Nuclear Management Company, LLC
Prairie Island Nuclear Generating Plant
1717 Wakonade Dr. East • Welch MN 55089

PRAIRIE ISLAND NUCLEAR GENERATING PLANT
Docket Nos. 50-282 License Nos. DPR-42
50-306 DPR-60

Response to NRC Questions Dated February 12, 2001

Prairie Island Response to NRC Follow-up Questions dated February 12, 2001 from the February 9, 2001 Meeting Regarding Unit 1 Steam Generator Eddy Current Test Results

Figure 1
 Structural Limit³, EOC Allowable Limit and Physical Repair Limit Curves
 for Axial PWSCC in Low Row U-bends

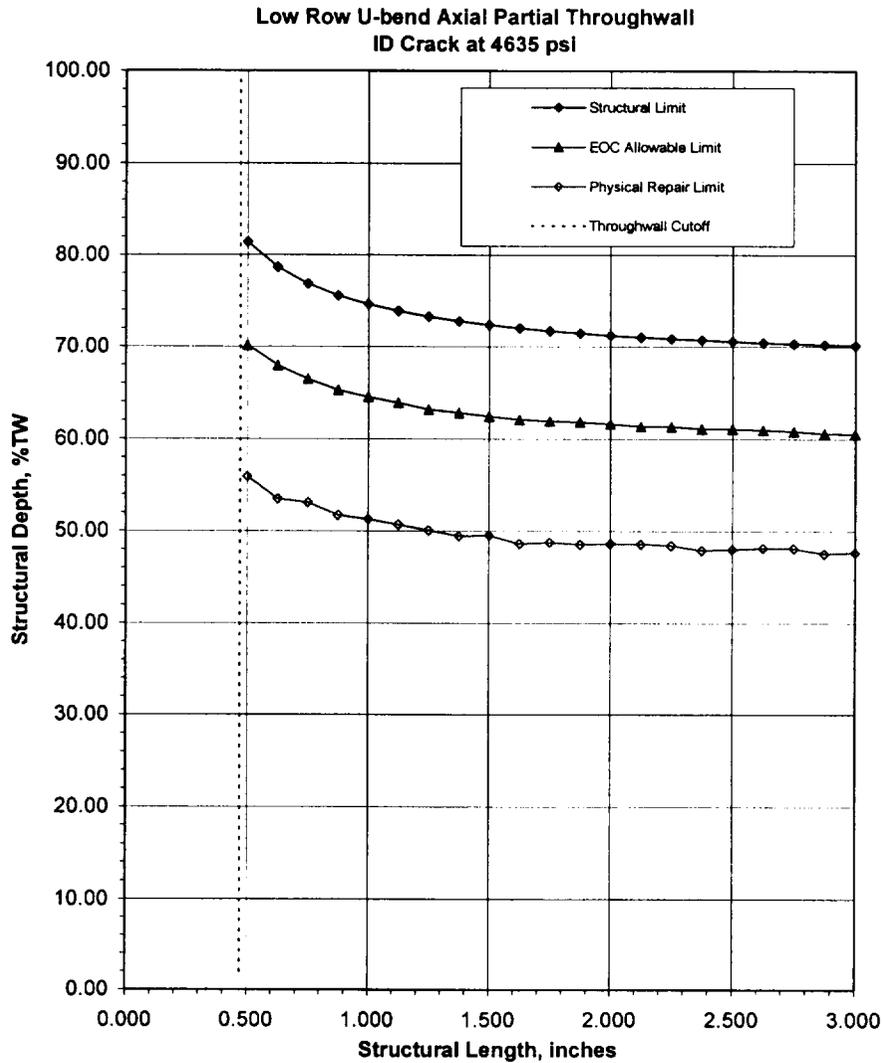
Figure 1 shows a plot of the structural depth versus structural length for ID axial cracks leading to a $3\Delta P$ burst pressure of 4635 psi at 0.95 probability for the best estimate structural limit, the EOC allowable limit and the physical repair limit. The EOC allowable limit includes material property and burst equation uncertainty. The physical repair limit defines the limit of the actual physical dimensions of cracks which must be found to ensure that minimum $3\Delta P$ strength requirements will be met at the end of the next cycle. The physical repair limit accounts for crack growth over the next cycle of operation. Figure 1 shows that axial ID cracks in U-bends with average depths of about 50% TW must be found by inspection to ensure structural integrity requirements over the next cycle of operation. Historically, Prairie Island has detected indications meeting the physical repair limits of Figure 1.

The burst equation used in Figure 1 is taken from the EPRI Flaw Handbook (in final publication), Section 5.1.4, Part-through-wall Axial Cracking. It is based entirely on

The growth rate distributions used to construct Figure 1 are the same as those used in the Westinghouse/E-Mech CMOA analysis for Indian Point Unit 2 (Figure 5.5).⁵ The log normal distribution of average depth crack growth rates has an upper 95th percentile growth rate of 12.9%TW/EFPY and a median value of 3.45 %TW/EFPY. The length growth rate distribution meets or exceeds that used in the Indian Point 2 CMOA.

Figure 4
 Estimated Lower Bound Burst Pressures
 From IP2 400 kHz NDE Crack Profile Versus Fitted Volts/Length Correlation

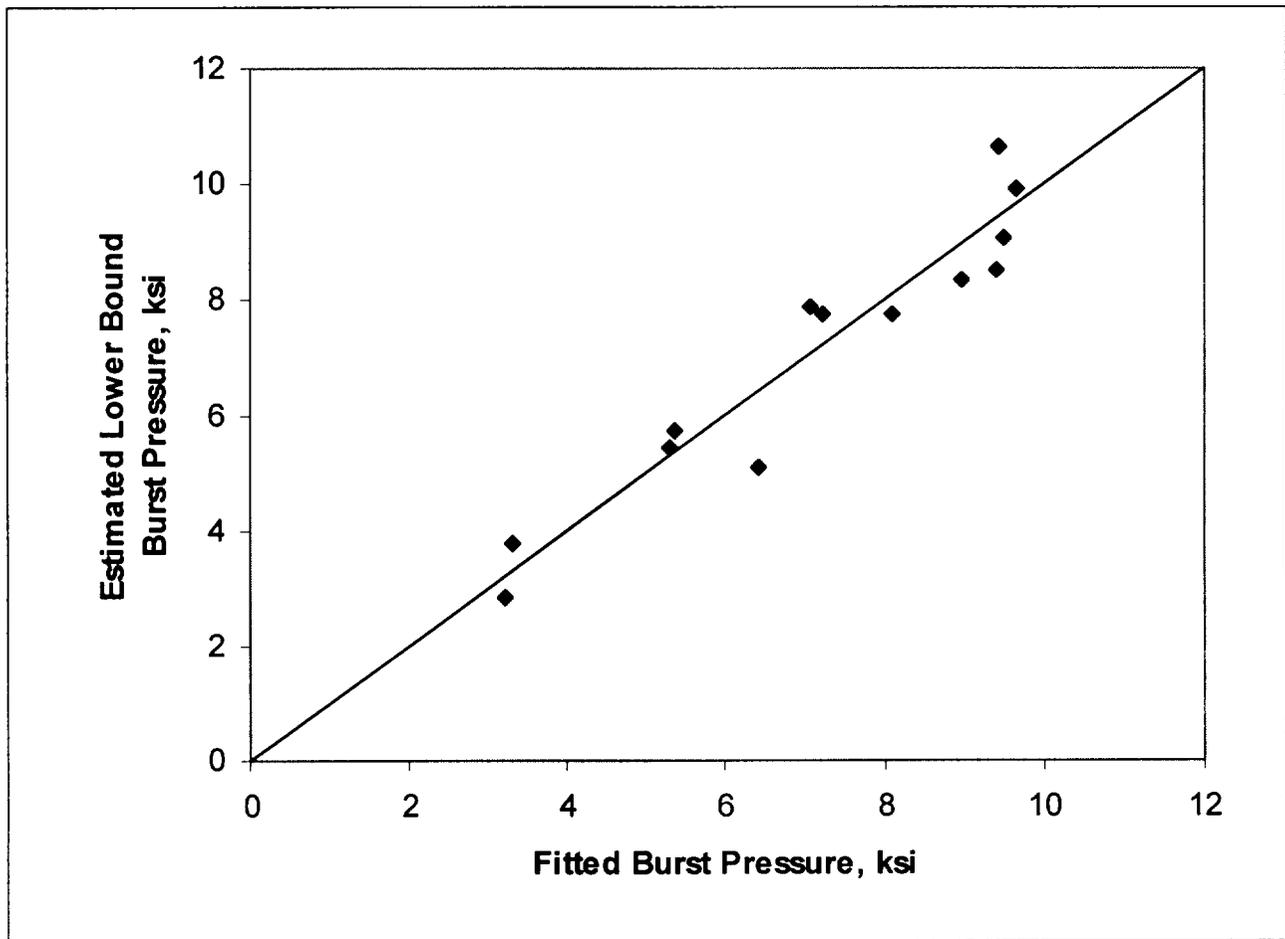
The third approach used to evaluate postulated axial cracks in U-bends deals directly with the question of +Point™ signal amplitude of cracks which must be detected and the ability to detect such signals in the Prairie Island Unit 1 U-bend eddy current signal noise. In this approach a correlation is needed between eddy current signal parameters and minimum expected burst pressure. Burst pressure depends on indication length

Figure 4 shows a plot of *ELBP* versus the fitted values from the above equation. The 13 point fit is excellent. The standard error of estimate about the regression line is 759 psi.

In order to meet a $3\Delta P$ burst pressure of 4635 psi after the next cycle of operation (1.512 EFPY) an allowance for scatter about the regression fitted burst pressure and growth of degradation over the next cycle must be considered. The limiting change in burst pressure for very long flaws is 115 psi for each increase in average crack depth of 1% TW. Shorter length flaws will decrease in burst pressure by a lesser amount. Thus the growth rate distribution can be converted into a distribution of strength decreases over the next cycle of operation. Using Monte Carlo techniques, the scatter about the regression line plus the distribution of strength decreases caused by crack growth over the next cycle of operation were combined to calculate the burst strength incremental allowance for scatter and crack growth, needed at the beginning of a cycle to ensure a minimum degraded tube burst strength at EOC of $3\Delta P$ at 0.95 probability with 95% confidence. This value is 2713 psi. Thus a regression equation burst pressure of

Figure 8
SG 11 Noise Levels – Mid Range Frequency

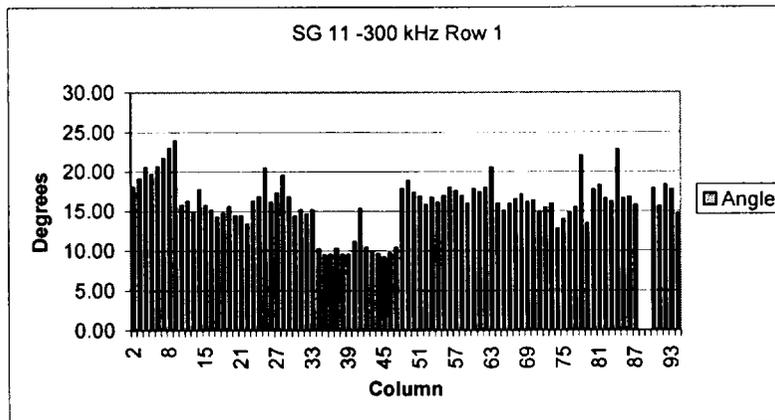
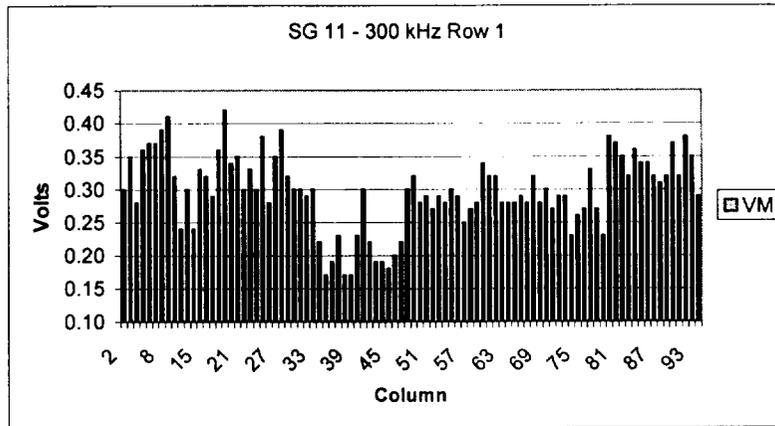
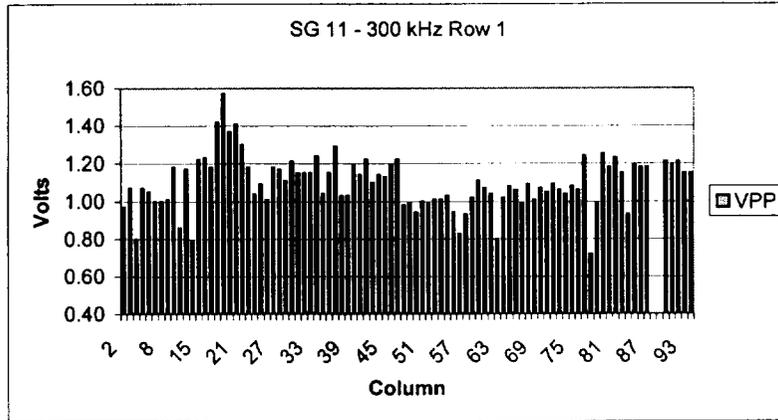
Discuss the criteria for reinspection and rejection of tubes, the basis for this criteria, and the outcome of all reinspections (e.g., changes in measured parameters).

11 SG contained the noisiest rows 1 and 2 U-bends. Figure 8 illustrates the noise levels in 11 SG row 1 U-bends. Those tubes exceeding the above noise criteria were retested with the high frequency probe. Figure 9 shows a decrease in the peak to peak noise levels. Also, Figures 8 and 9 include a plot of the phase angle calculated from the peak to peak volts and the vertical maximum volts for each tube.

Figure 14
 Prairie Island Dents per Inspection Year, Grouped by TSP Location

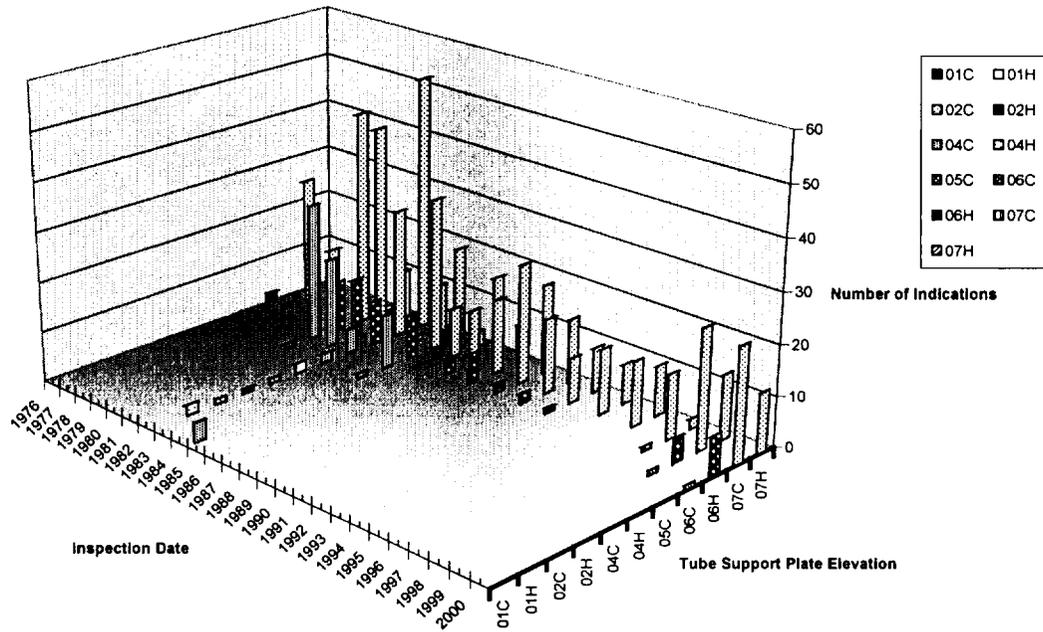
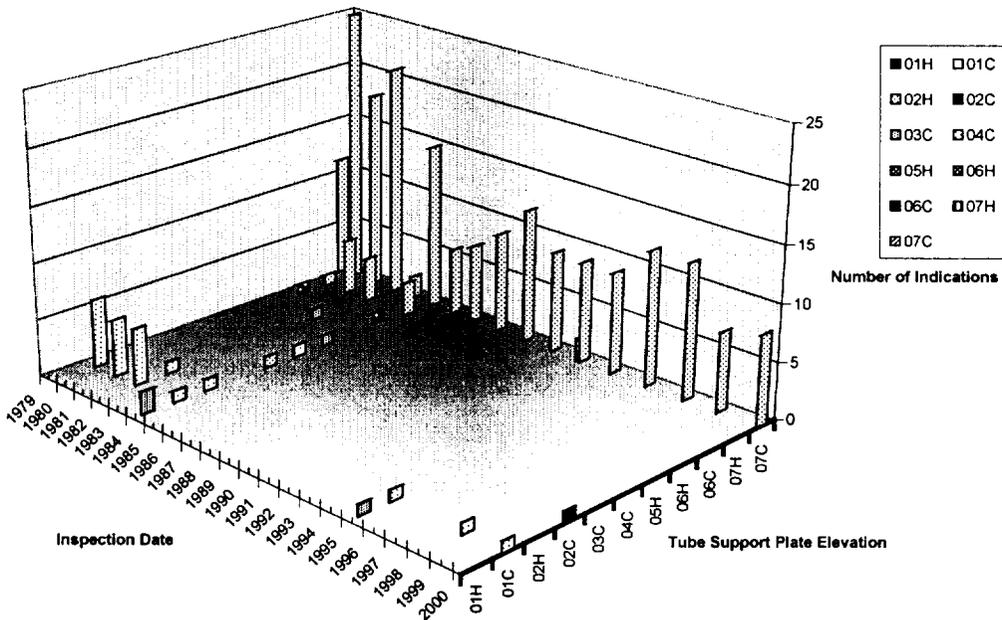
Provide a summary of the location and magnitude of tube dents that are in the PINGP, Unit 1, steam generators. Discuss how the number and size of these dents has changed over time.

Figure 14 shows the trend of the number of dents at each tube support plate elevation, separately for cold leg and hot leg. No dents have been found lower than the 6th tube support plate since 1986. In the 2001 inspection, one of the dents is in row 6, the other nine are in the outer periphery beyond row 40 .

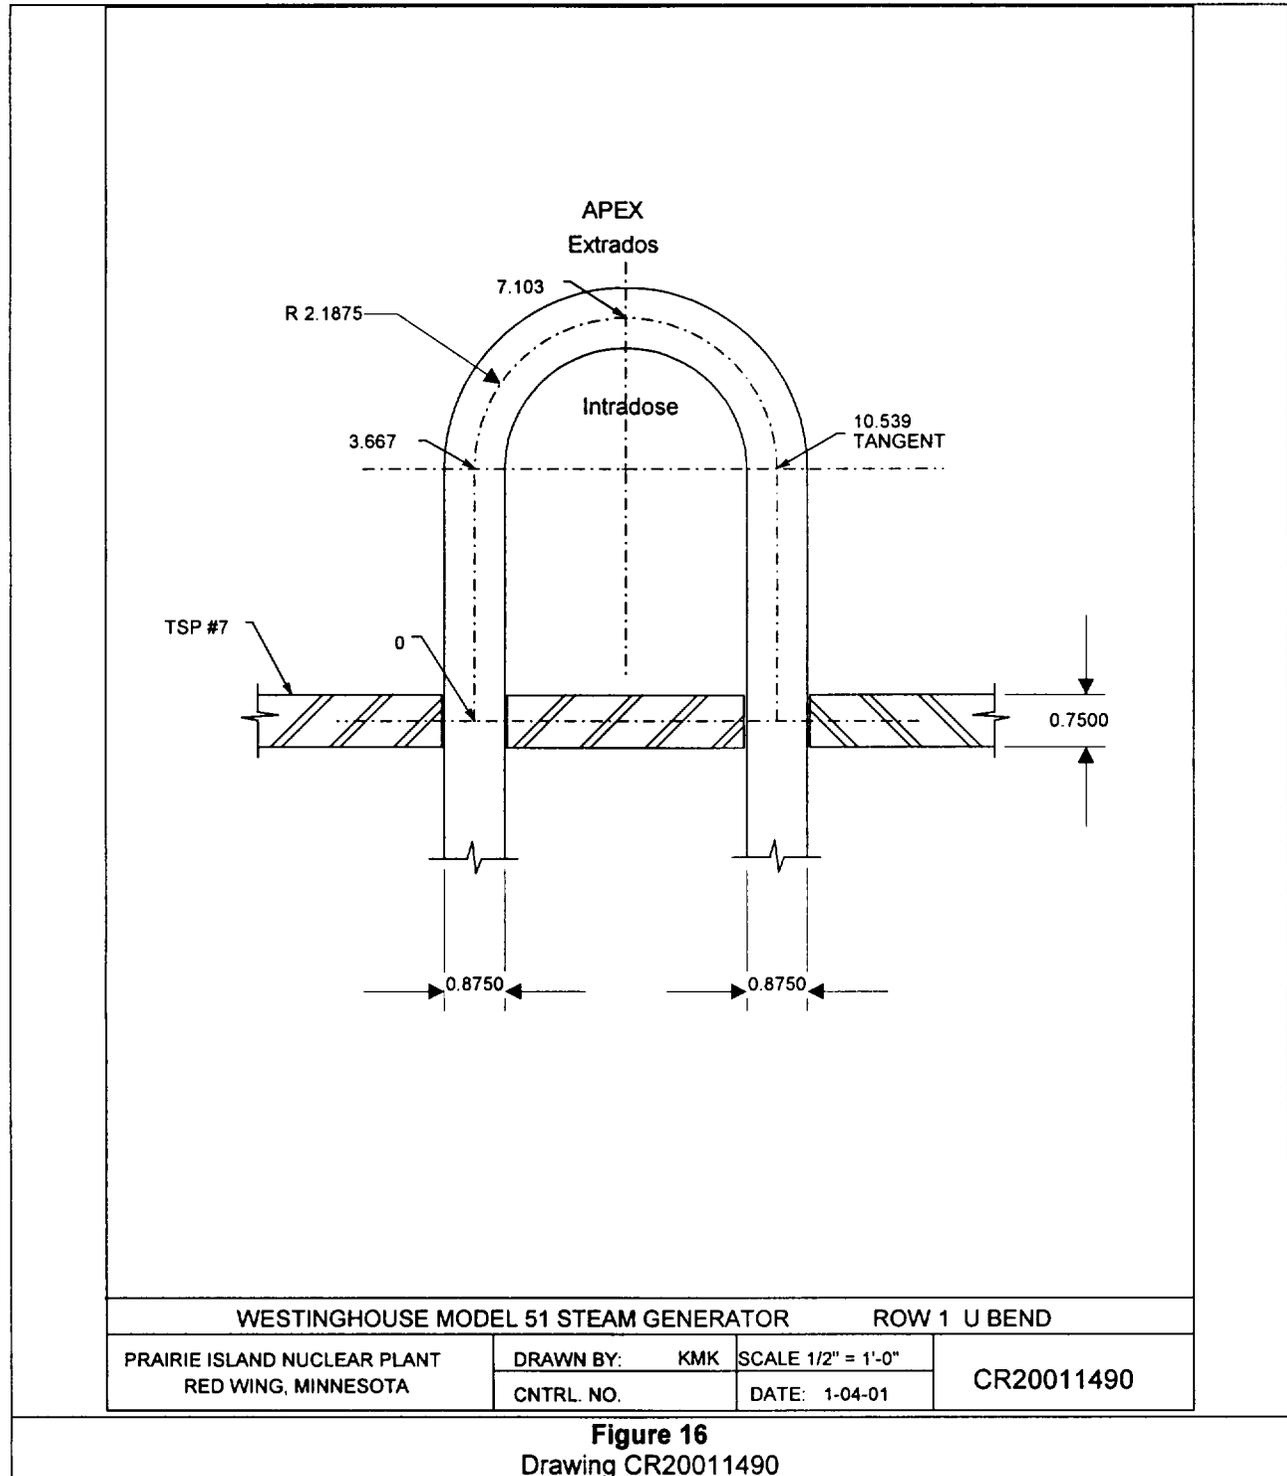
Provide a complete description of the location in the steam generators of the U-bend circumferential indications found in the February 2001 outage at PINGP.

Refer to Figure 16. The location of the circumferential indications (07H+~7.8 inches) is on the intradose of the U-bend about 0.7 inches from the apex on the cold leg side.

Figure 17
Eddy Current Data for Prairie Island R1C52

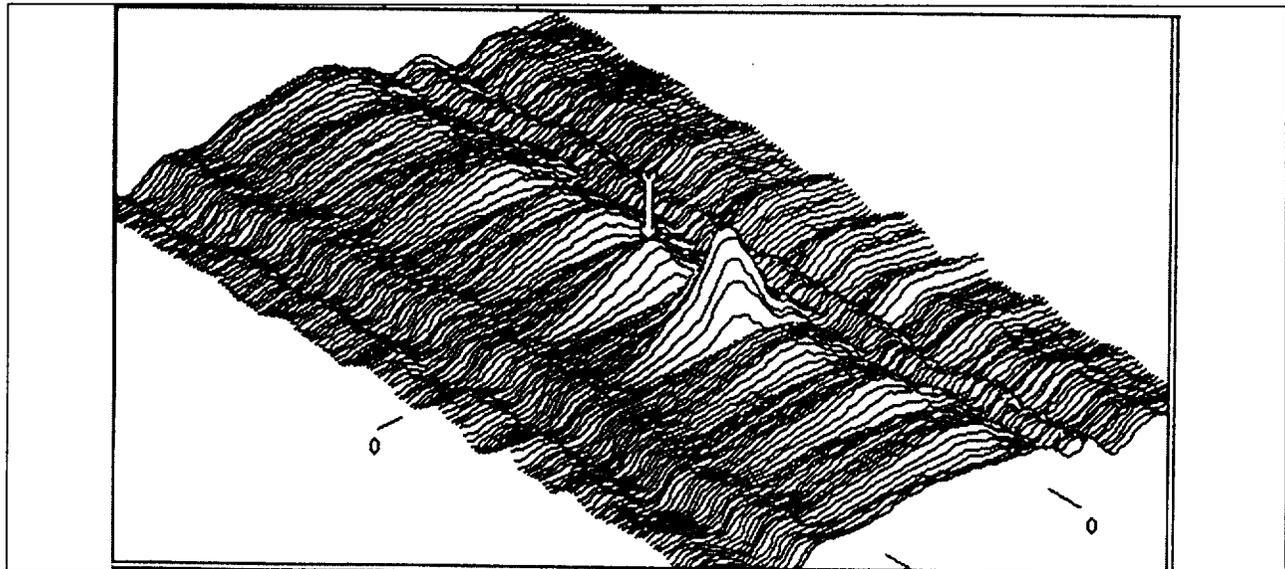
Discuss the results of your hindsight reviews of eddy current data performed on row 1 and row 2 tubes.

Figure 17 shows Prairie Island R1C52 eddy current data. Figures 18 and 19 show the eddy current c-scan of an EPRI U-bend qualification data set with horizontal ridges similar to R1C52. Thus, the horizontal ridges are not unique nor is a circumferential indication on the intradose of row 1 U-bend in the region between the two tangents. It is postulated that high stresses from the tube bending process physically change the intradose and the primary water stress corrosion cracks grow until high residual stresses are relieved. The ridges are due to the bending process.

There is essentially no growth in R1C52 when evaluating previous RPC data back to 1991.
